Product Support Bulletin 2008-009

Maintenance of Way ~ Work Equipment Bulletin

SUBJECT: Hand Controller Stop Ring Kit - 98760035

**MACHINE
MODEL(S):** TRIPP

Figure 1
Components of Kit 98760035

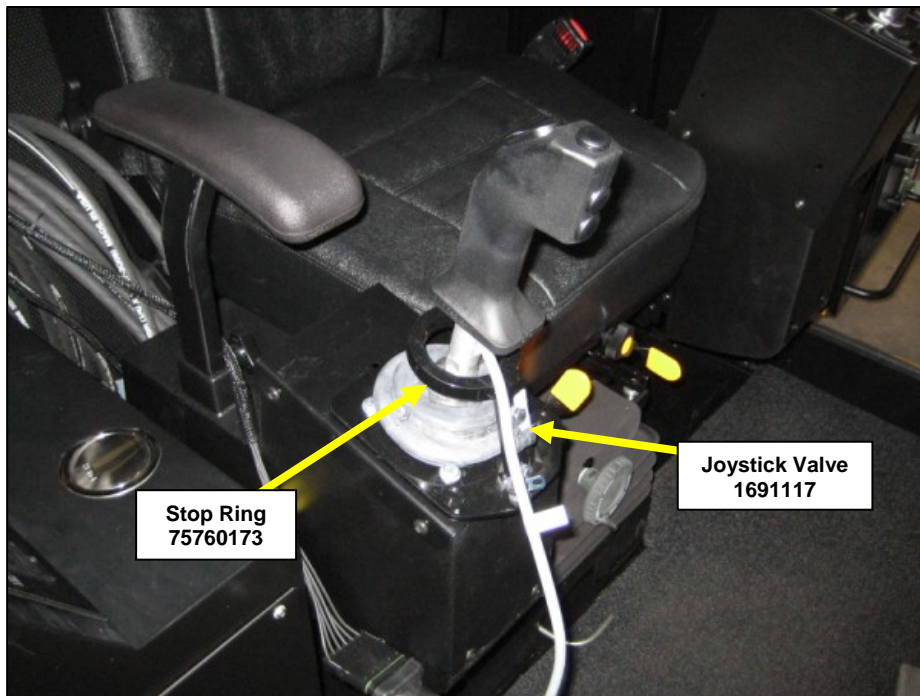
SUMMARY: The Joystick Control Handle can break if the Joystick Valve, 1691117, is moved too far or moved with too much force. To help prevent this, the **98760035 Stop Ring Kit** has been designed and is now available.

ACTION: The kit consists of the **Stop Ring, p/n 75760173**, cable clamps, mounting hardware and installation instructions. See Figure 1 on Page 2 for the parts included in the kit. The Joystick Valve will have to be removed to install the Stop Ring. Installation of the kit should take about 30 minutes. The installed kit is shown in Figure 2 on Page 2.
